ADDENDUM 3

ADDENDUM DATE: May 8th, 2019

PROJECT: OCSC Expansion - Phase 1, Seymour Center
2551 Homestead Rd.
Chapel Hill, NC 27516

Addendum #3

C2-10

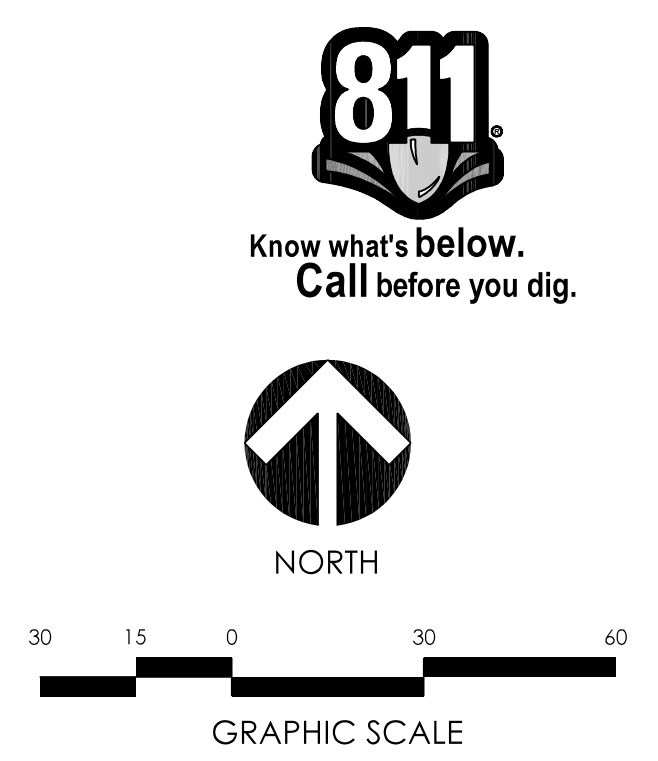
12. Site Demolition Note #20 has been added to sheet C0-01. (Refer to sheet C0-01)
13. The approximate location for the temporary construction trailer shown on sheet C2-10 has been revised to be outside of the public right-of-way at the Town's request. (Refer to C2-10)

C3-10

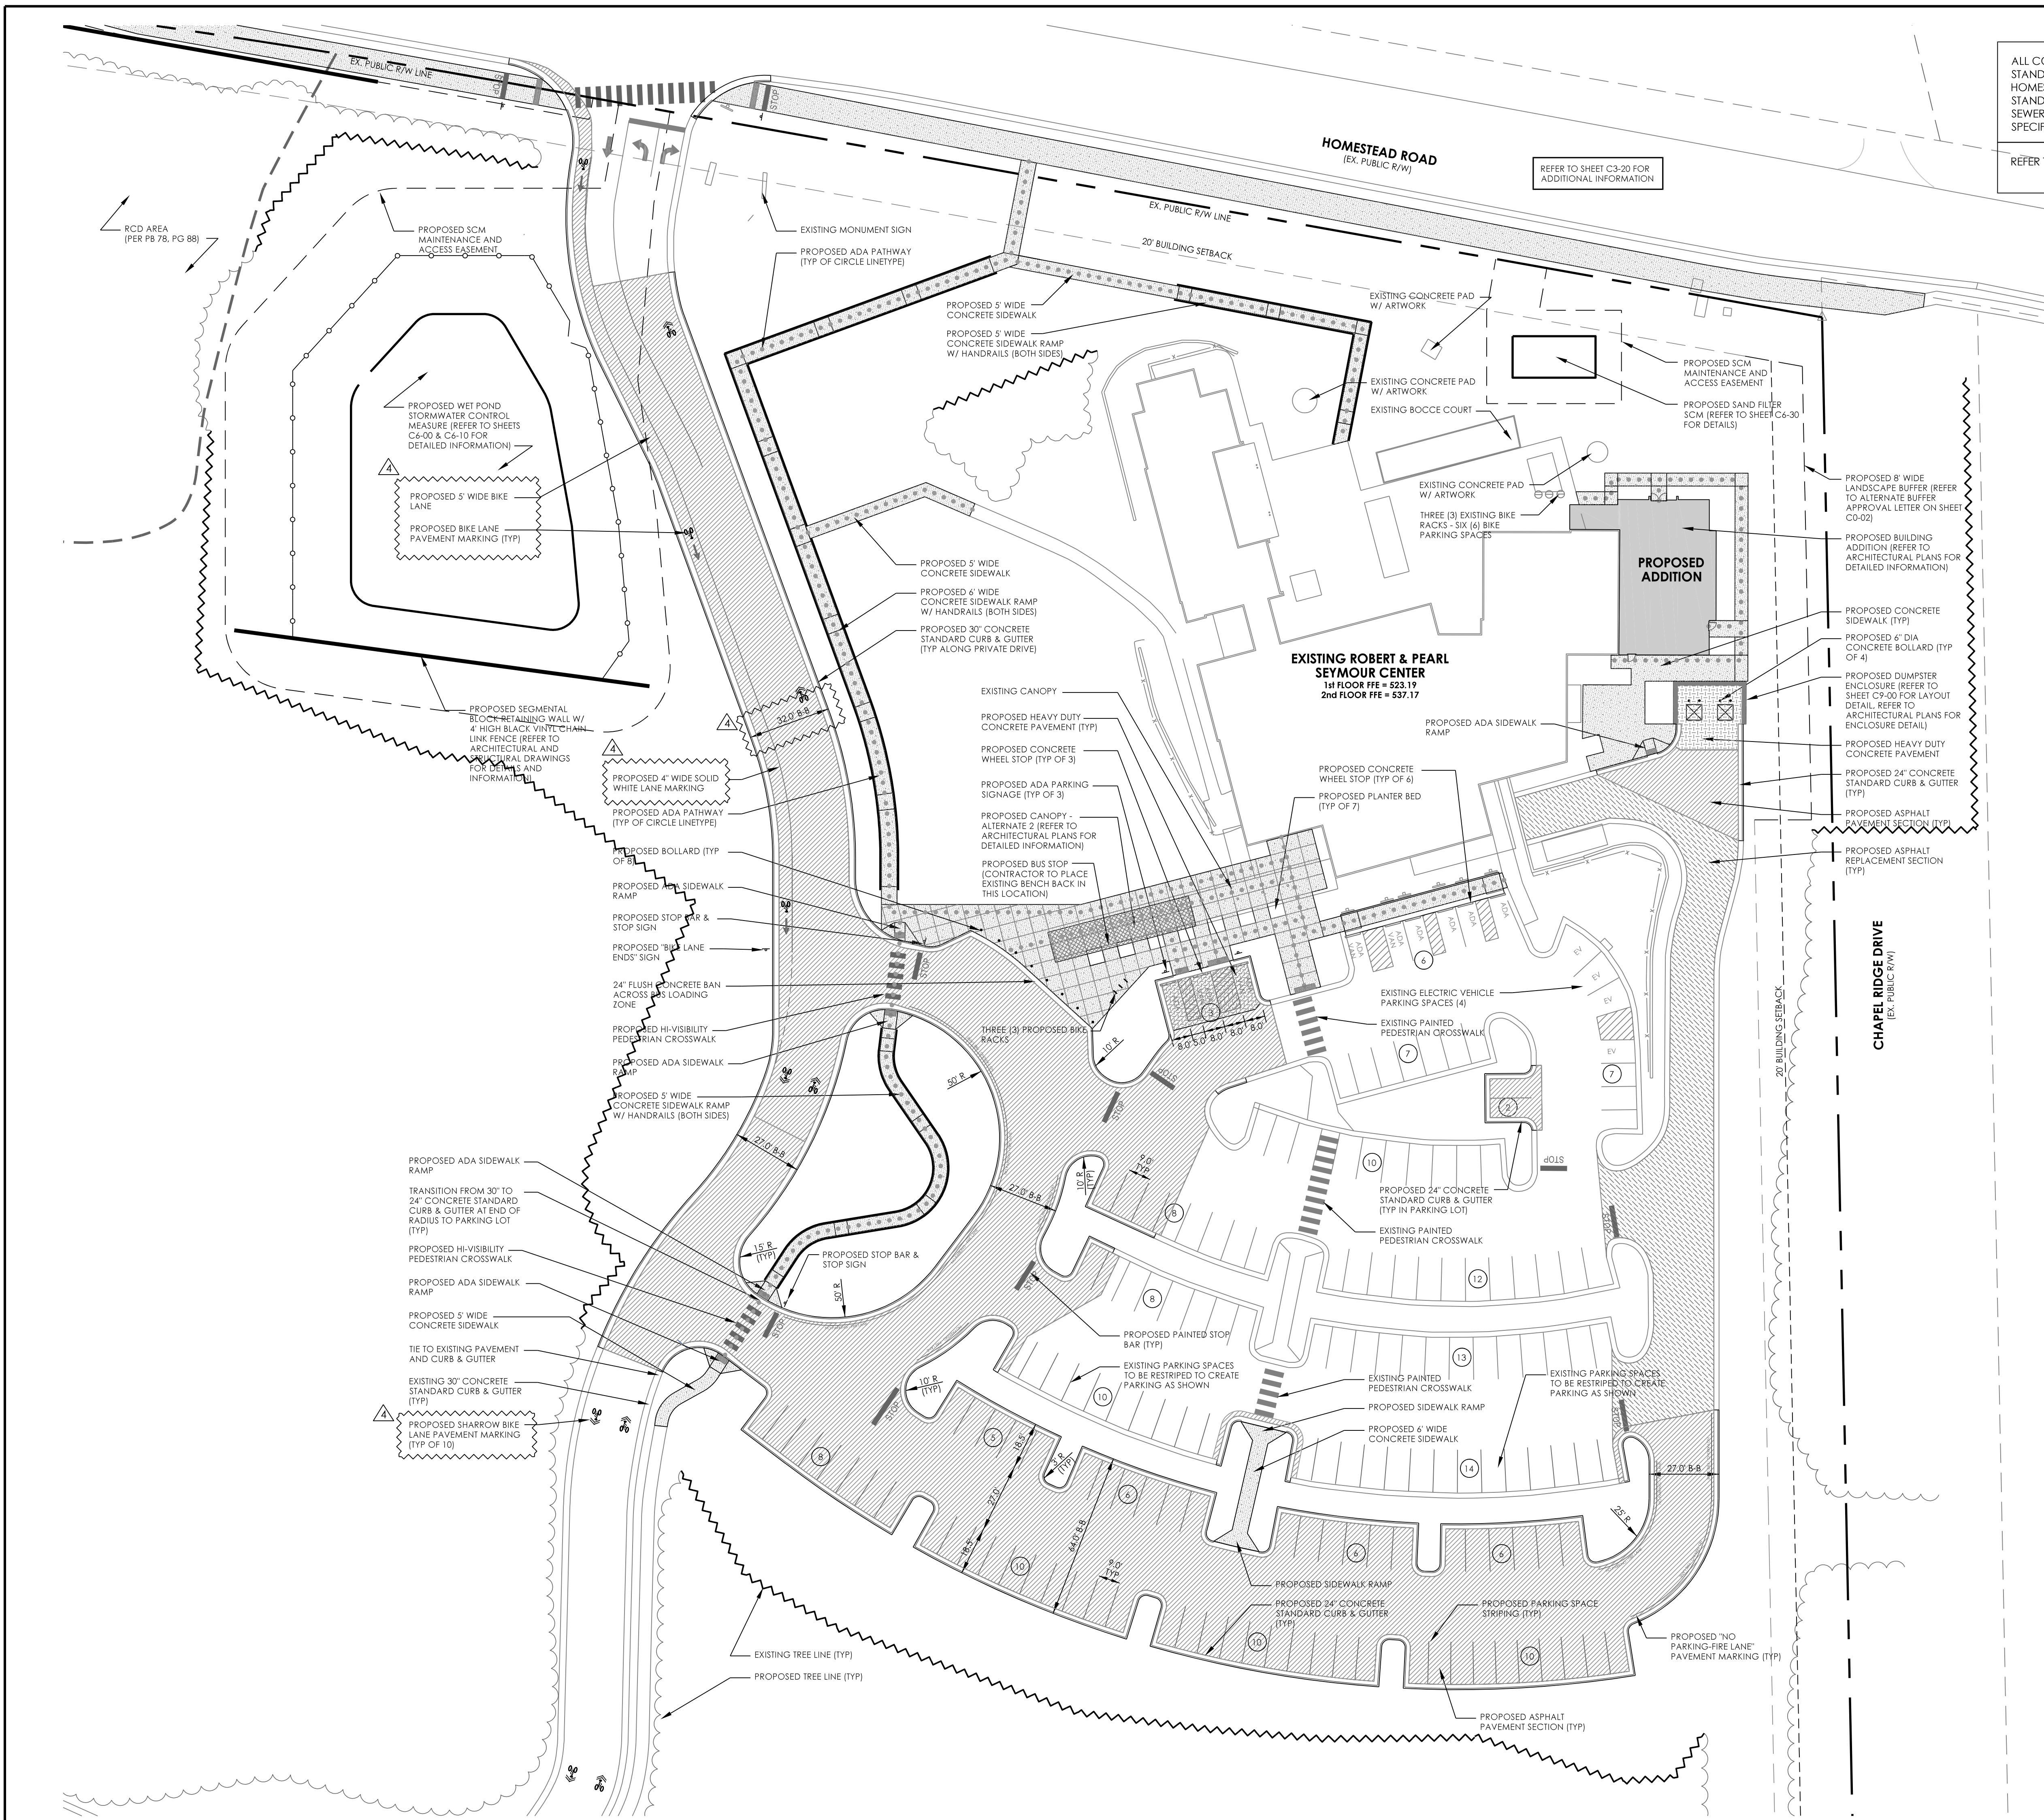
1. The driveway into the site has been widened from its connection to Homestead Road to the first driveway into the Seymour Center to accommodate a Town required bike lane. Pavement markings have been provided along the entire length of the driveway (both improved and non-improved sections) to support the bike lane and to provide sharrow pavement marking. A "Bike Lane Ends" sign has been added along the proposed realigned driveway. Pavement marking details and bicycle sign details have been provided. (Refer to sheets C3-10, C3-20, C9-04)

**STORMWATER
MANAGEMENT
DETAILS**

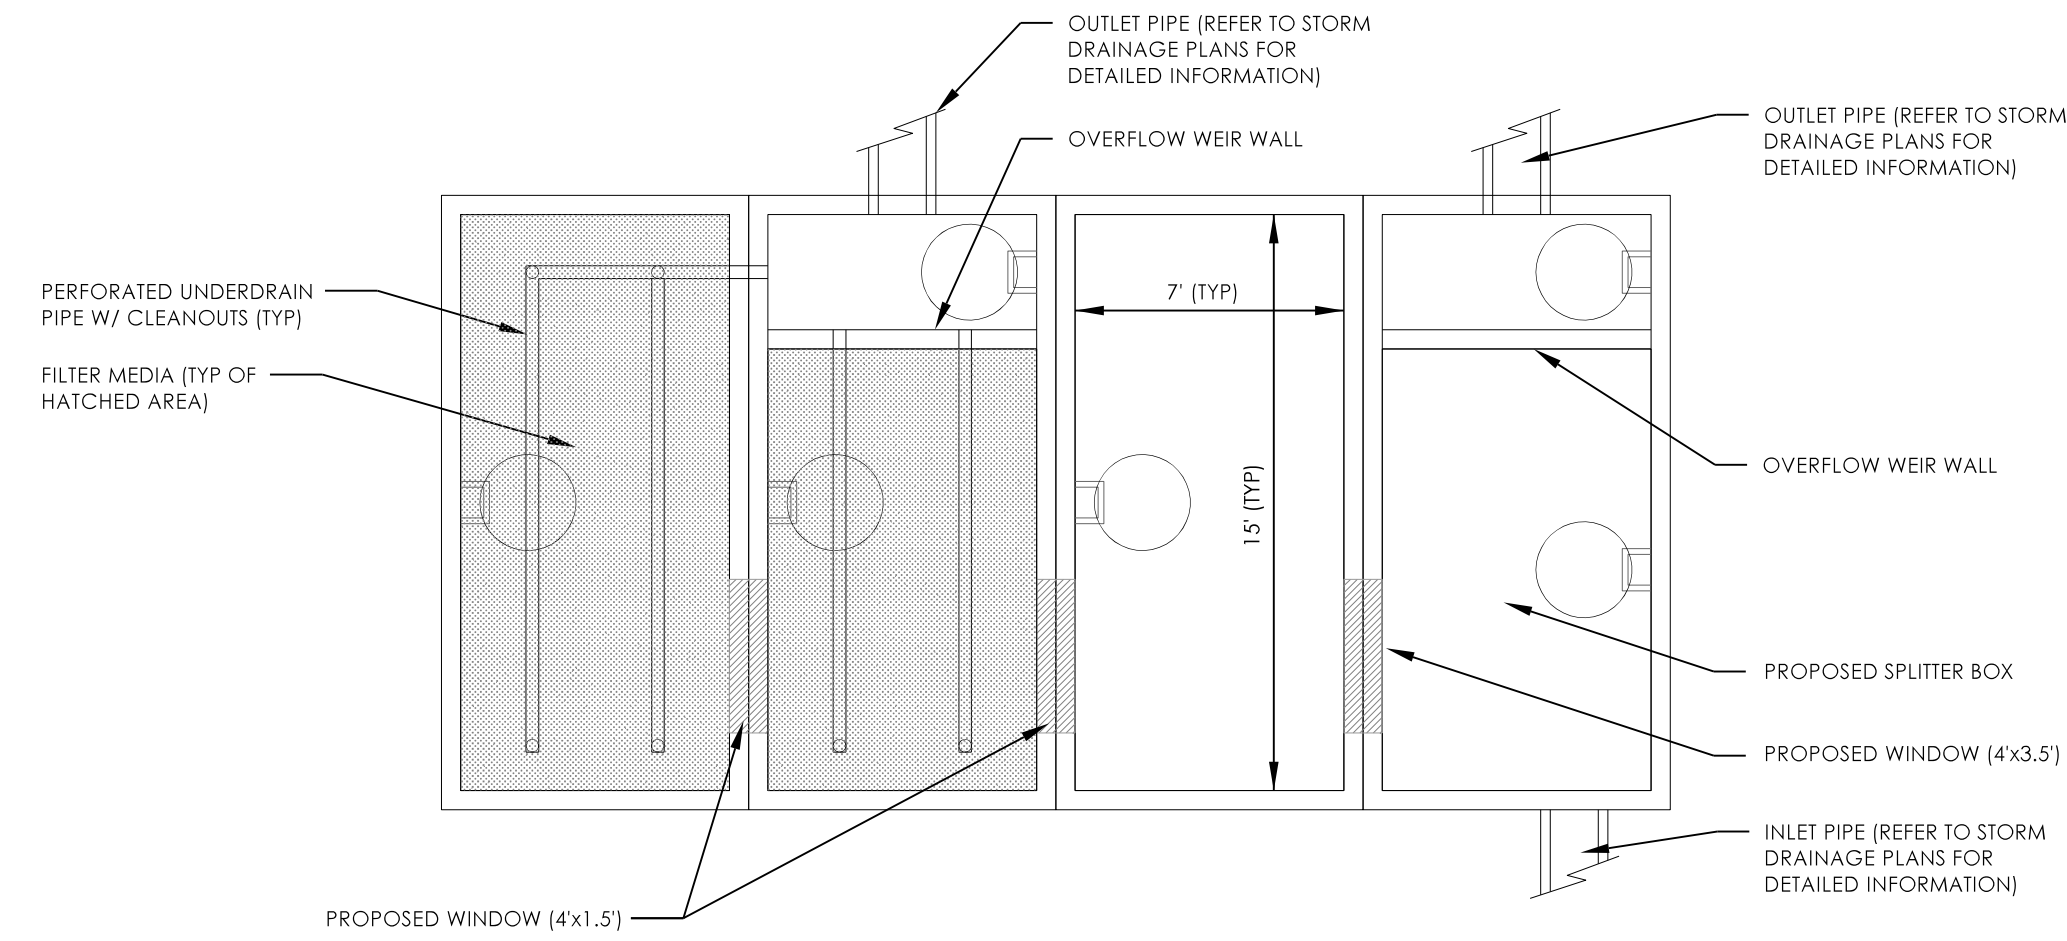
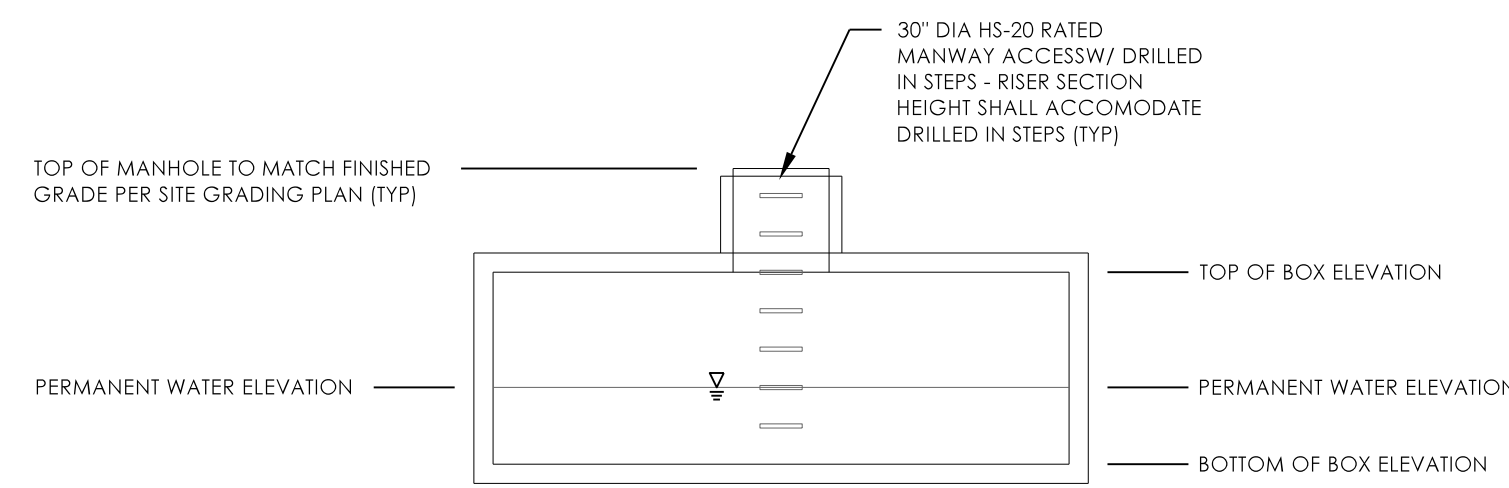
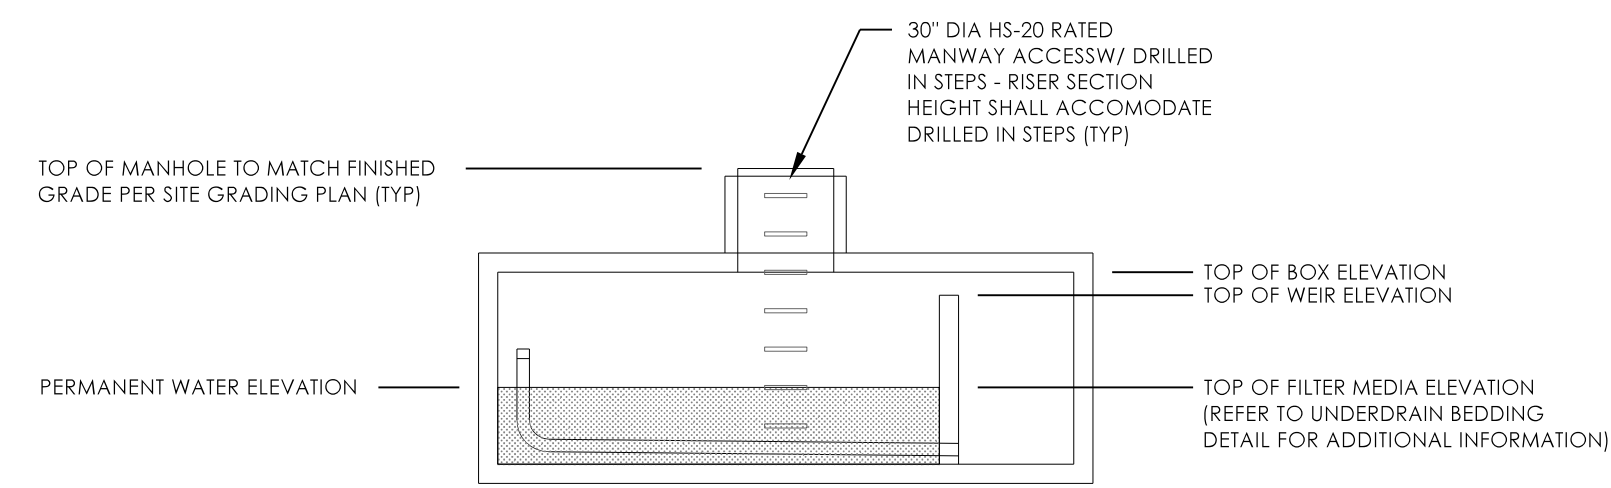
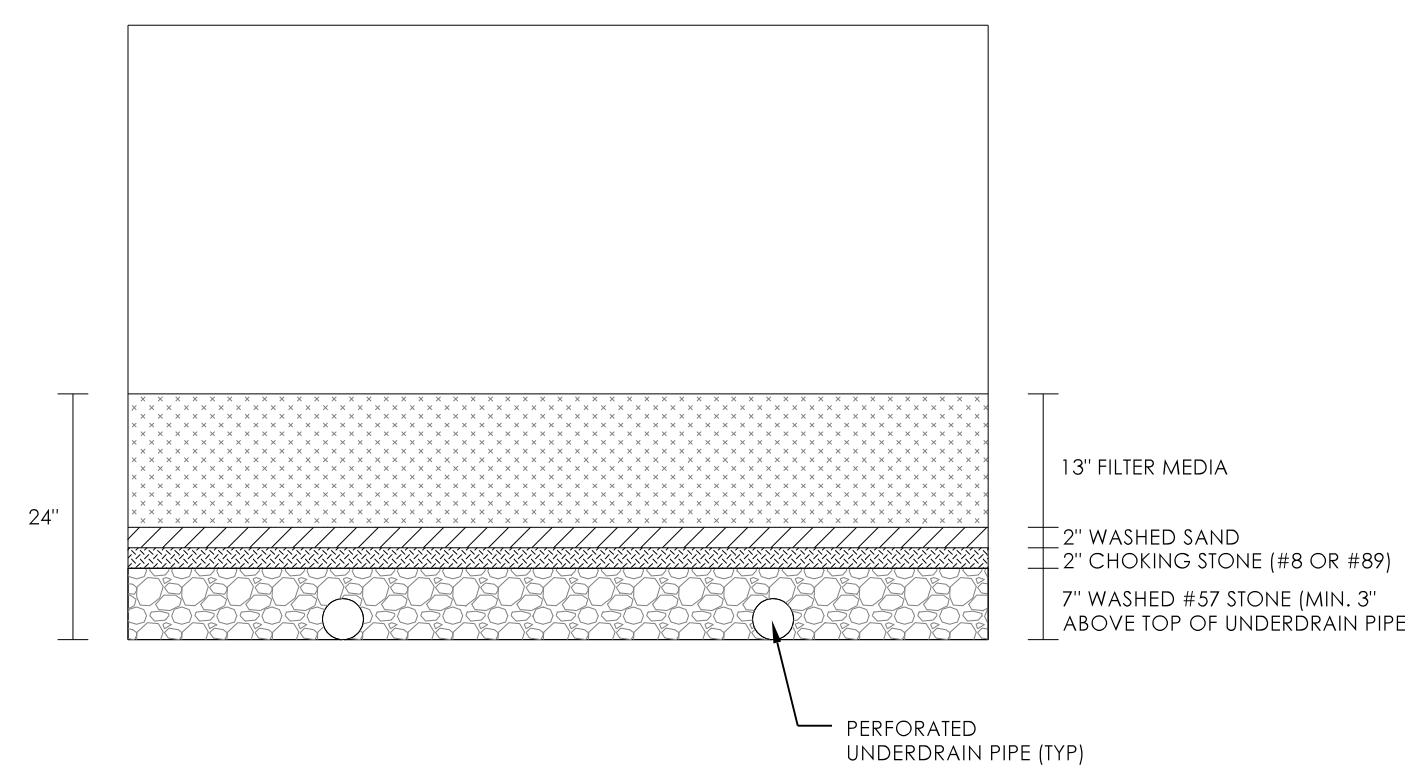
5. Additional detail and revisions have been made to the proposed sand filter system including but not limited to the "Underdrain Bedding". (Refer to sheet C6-30)

6. Note #2 on sheet C6-30 has been modified. (Refer to sheet C6-30)
7. A "Proposed Driveway Section w/ Bike Lane" detail has been added. (Refer to sheet C9-02)

MULTI-PURPOSE PATHWAY ADA RAMP

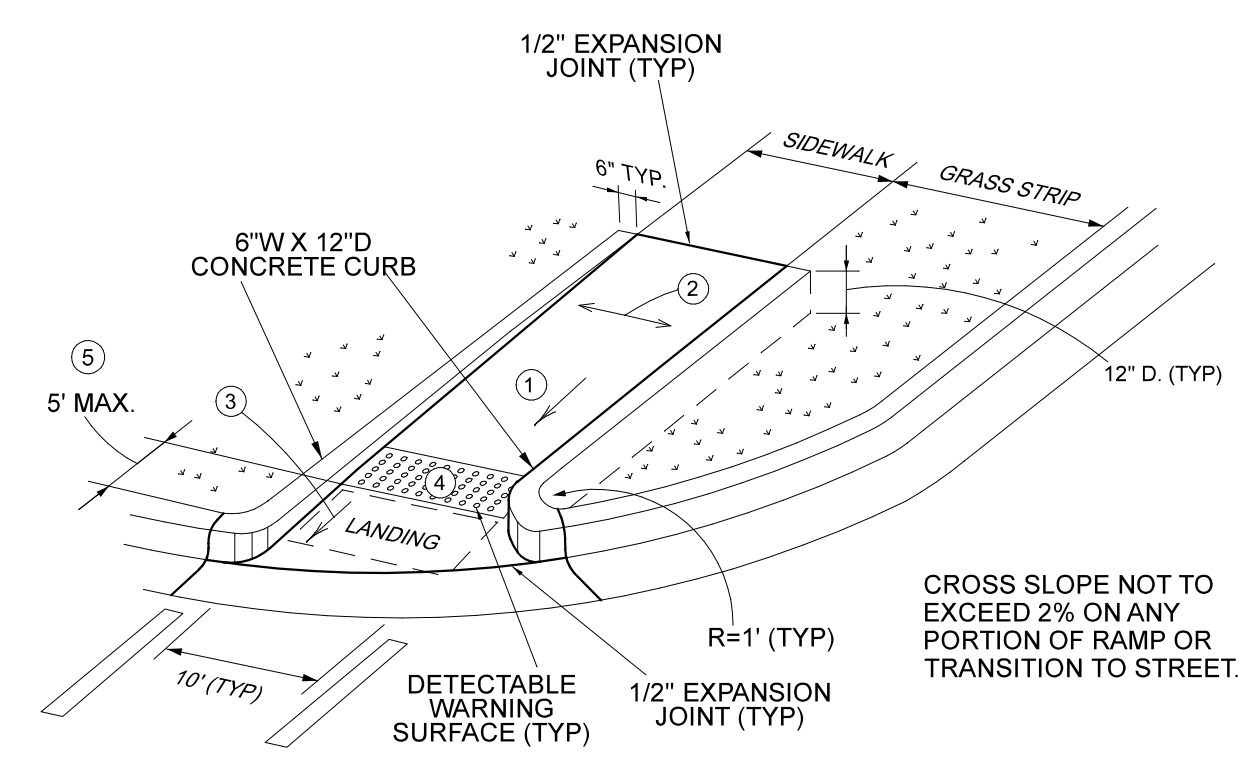
2. A "Multi-Purpose Pathway ADA Ramp" detail has been added. (Refer to Sheet C9-04)
3. The storm drainage table has been updated per the revisions to the driveway improvements. (Refer to sheet C5-30)
